## SERVICE INFORMATION LETTER

FROM: JetProp LLC

SUBJECT: Manual Override Linkage Upgrade

TO: JetProp Owners (Jetprop Numbers 1-173)

DRAWING TITLE:			
ACCESSORIES CONTROLS & EQUIPMENT INSTALL			
SHEET	DRAWING NUMBER:	REV.	
6 OF 7	560.07.200	S

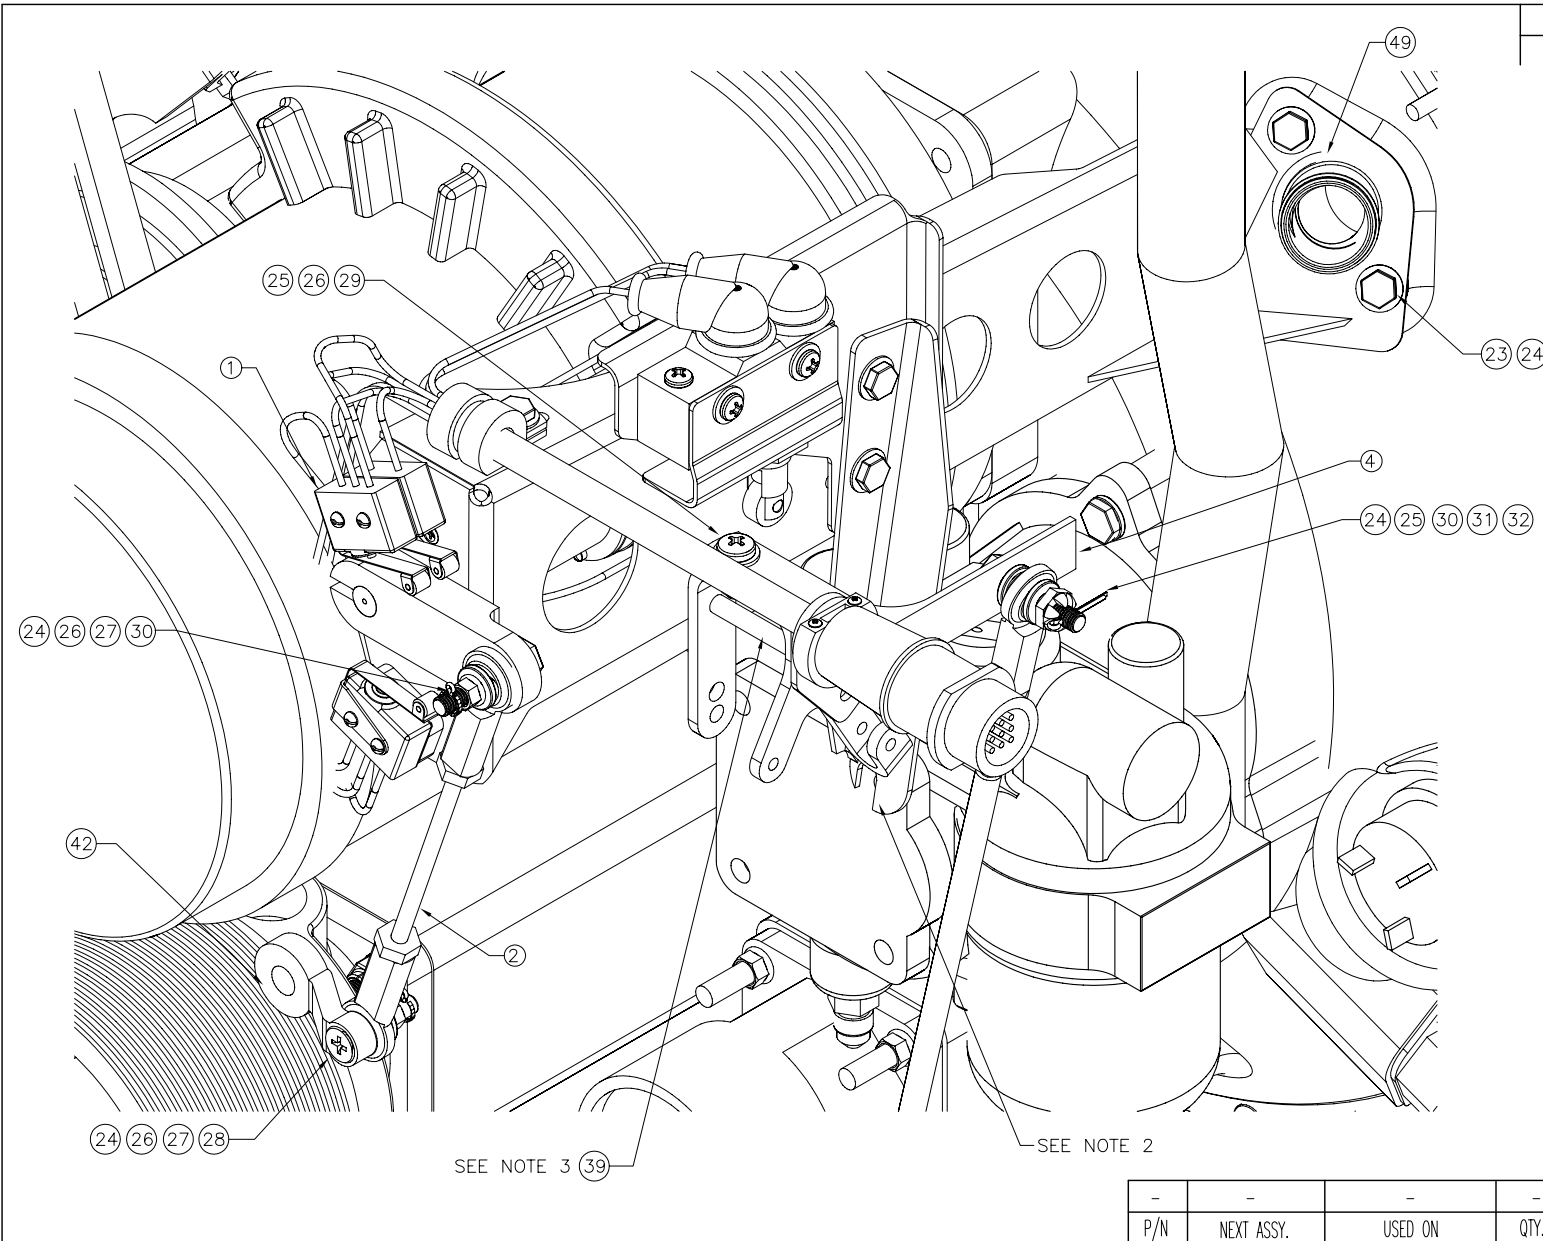
1. Remove the top cowling.
2. On the right side of the engine just forward of the firewall locate the manual override linkage (See Drawing 560.07.200 Rev S, Sheets 6 & 7). We will be changing the hardware on each end of the linkage.

4. Replace the upper attachment hardware with an AN3-10 bolt, AN960-10 washer, MS21042-3 lock nut, and MS24665-067 cotter pin as shown in drawing 560.07.200.

5. Replace the lower attachment hardware with the 560.07.236 Screw, AN960-10 washer, MS21042-3 lock nut, and MS24665-067 cotter pin as shown in drawing 560.07.200.
